LOCAL HISTORIC DISTRICT: Dilworth

PROPERTY ADDRESS: 2215 Dilworth Road West

SUMMARY OF REQUEST: Detached garage

Charlotte Historic District Commission - Case 2016-250
Accessory Structure
HISTORIC DISTRICT: DILWORTH

Project Description – Update

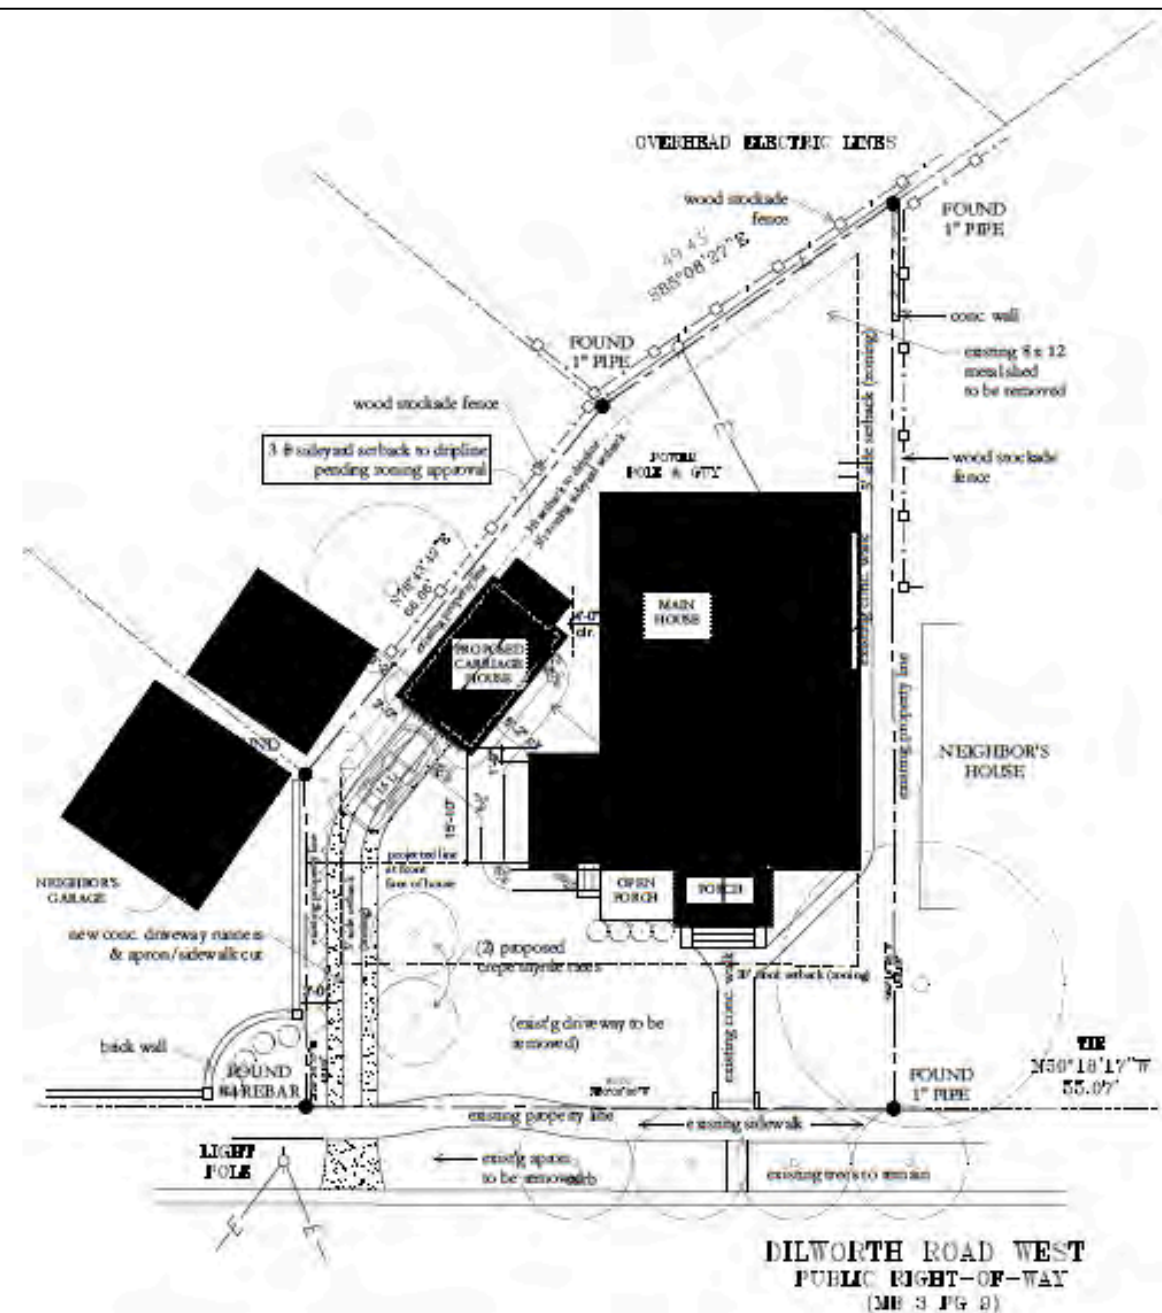
This revised application accommodates these concerns by sliding the proposed footprint back as far as possible into the rear side yard and relocating the workspace bump out. The new location and revised structure provide four major improvements:

1. The structure now starts more than 15' behind the front house facade, and 30' feet from the front setback.
2. A full car length can now be accommodated on the carriage tracks in front of the structure and entirely behind the front facade. (One vehicle can be stored in the carriage house and another on the carriage tracks without passing the front facade of the house.)
3. The new location further obscures the structure's view from the front yard and street elevation.
4. In addition to the existing vegetation on the left side approach, two flowering trees have been added to the right to create a tunnel-like effect, which further screens the structure and allows it to visually recede into the landscaping.

The revised location now adheres to all guidelines except for Accessory Buildings (pg 50 #1). Though historically there was a garage behind the house, the unconventional lot shape renders it impossible to build a functional garage in the rear yard due to the 50% impermeable coverage rule (*Guidelines*, pg 39) as well as the extremely narrow curve behind the house (too tight to safely maneuver a car with existing fencing and property lines).
